STAFF RECOMMENDATION

2403 Fairfax Avenue

September 19, 2012

Application: New construction - infill

Site Plan

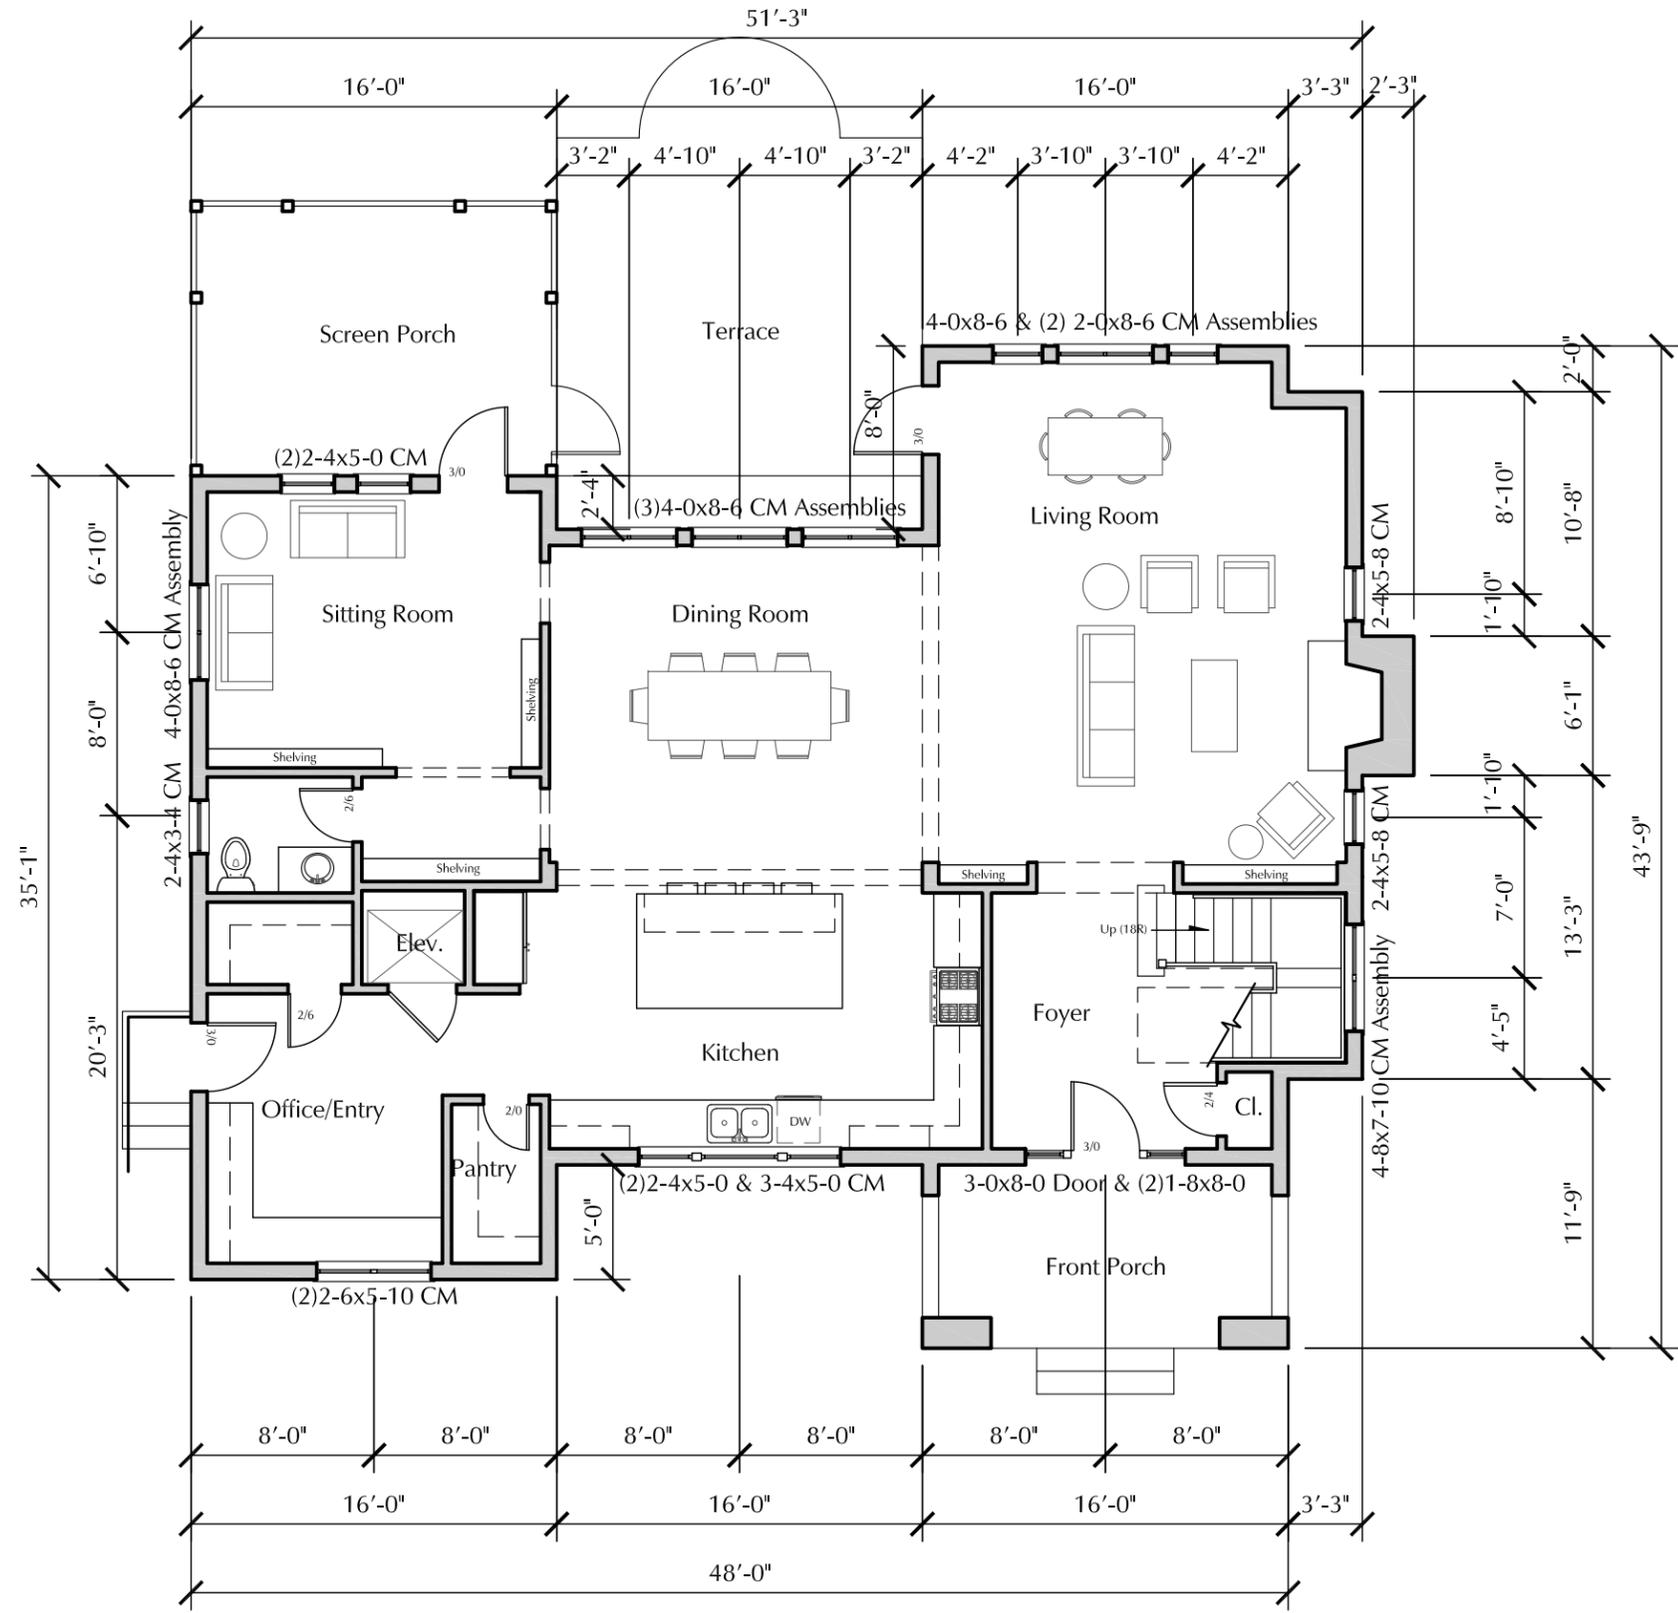
Scale: Historic lots in the immediate context have approximate open space ratios of between eleven percent and twenty-one percent (11%-21%). The proposed open space ratio figured with proposed garage, even though it is not a part of the current application, will be approximately twenty percent (20%).

Setback and Rhythm of Spacing: The front setback shall match the setback of the existing historic dwelling to the right (2405 Fairfax Avenue), which appears to be the closest historic building in the immediate context of varied setbacks. Side setbacks are approximately five feet (5’) and the project meets all requirements of bulk zoning.

Orientation: The new home will be oriented towards Fairfax Avenue with a front porch and main entrance facing the street and a concrete walkway leading from the entrance to the sidewalk. Primary vehicular access will be from the alley; however, there will also be a curb cut on Fairfax Avenue. The majority of homes on this block also have curb cuts on Fairfax Avenue. The driveway will continue to the mid-point of the house. This orientation is appropriate for the neighborhood.

Accessory: An accessory structure is planned and shown on the site plans but elevations were not submitted as a part of the project.

1 First Floor Plan
 Scale: 1/8"=1'-0"

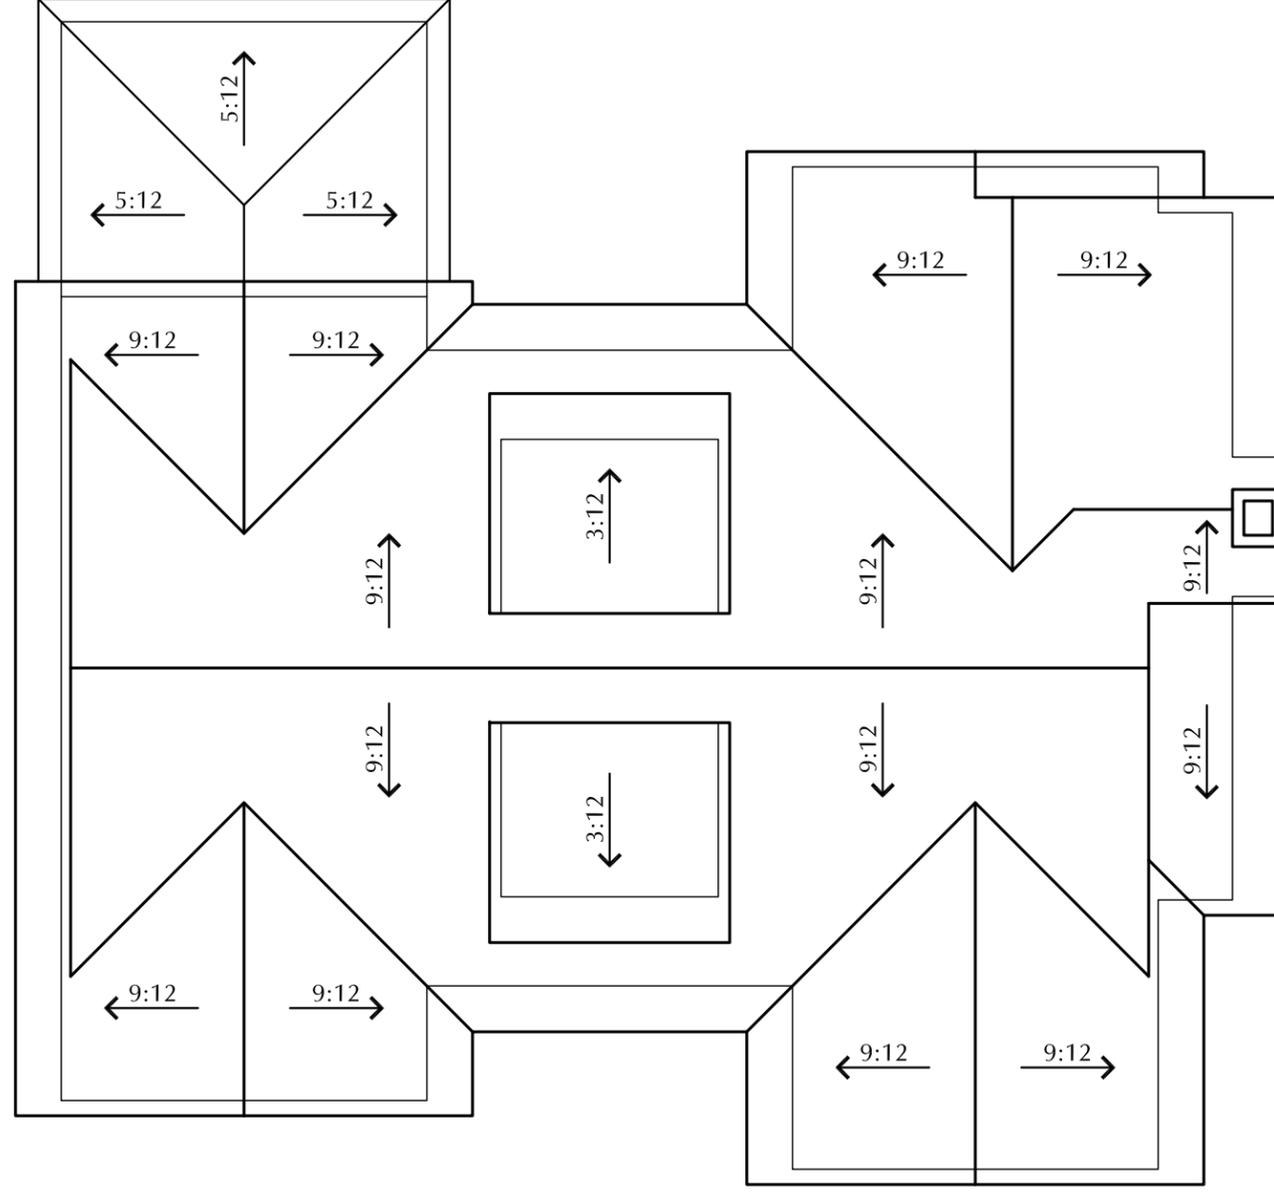
The full width of the house is fifty one feet and three inches wide (51'3") not counting the right chimney. The front massing of the house is forty eight feet (48') wide. Historic homes in the immediate context range between forty to forty-five feet (40'-45'), not counting side carports and the rare exception; however, all these homes are also one-story homes. The closest two-story homes are approximately thirty-six feet wide. Staff finds

that the width of the house, coupled with the proposed height is out of scale for the neighborhood.

Appropriate scale is also determined by a massing and form that does not greatly differ from the historic context. The form of the structure is essentially a two-story “piano box” of which there are a few one-story examples in the neighborhood but not two stories. The massing of this form is more typical of multi-family structures on larger lots than a single-family structure on a single lot. Since the alterations to the form and width affect every other aspect of the home both inside and out, Staff did not find that a simple condition was achievable and so recommends disapproval of the project as not meeting section b.
